# KOTO ADC Boards – 1.2V Power Caps

Mircea Bogdan  
12/10/2015

The University of Chicago

# Hardware Solution

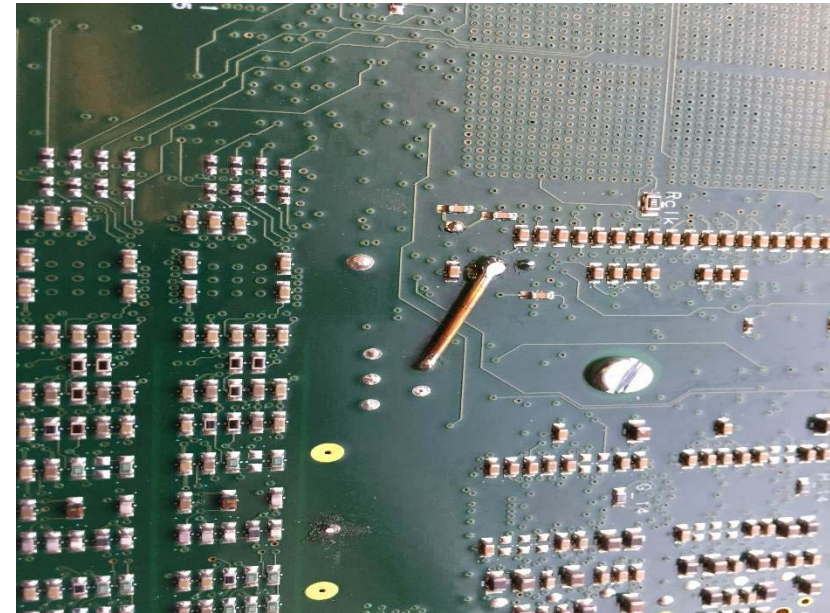
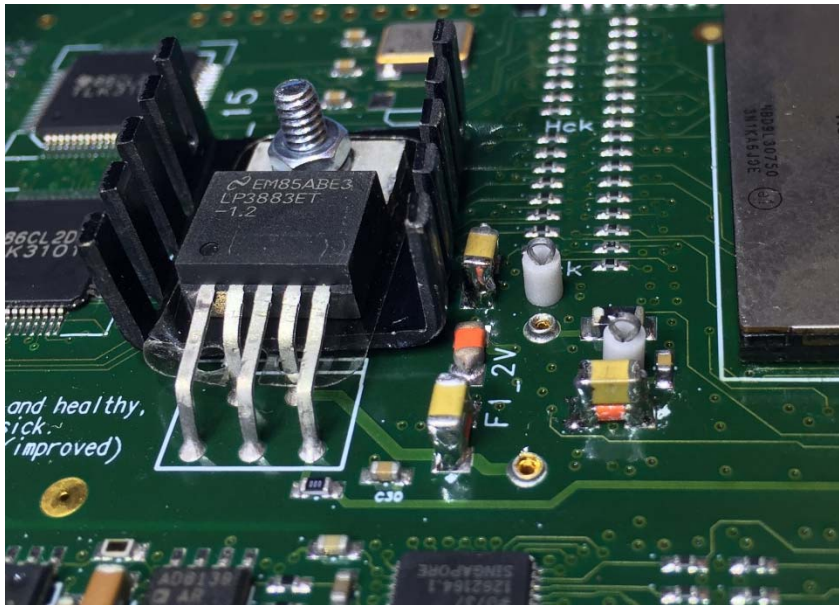
The added caps are the 3 yellow ones in the picture.  
Their sizes are 1206; part # GRM31CR60G227ME11L

**On Top Side:**  
Install three 220uF ceramic caps over  
C26, C27, C29.

**On Back Side:**  
Install wire jumper as shown.
